PRODUCT CHANGE NOTIFICATION

E-Switch Series/ Part No affected: TL1275 series, all PNs. See list below.	Part /Series Description: Tact Switch

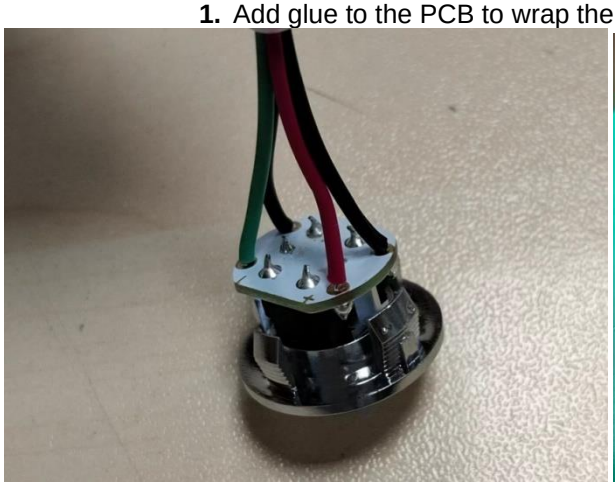
1. Improve tensile strength of wire to PCB connection. To prevent wires breaking during handling.
2.

1. Add glue to the PCB to wrap the root of the conductor and the plastic outer covering together
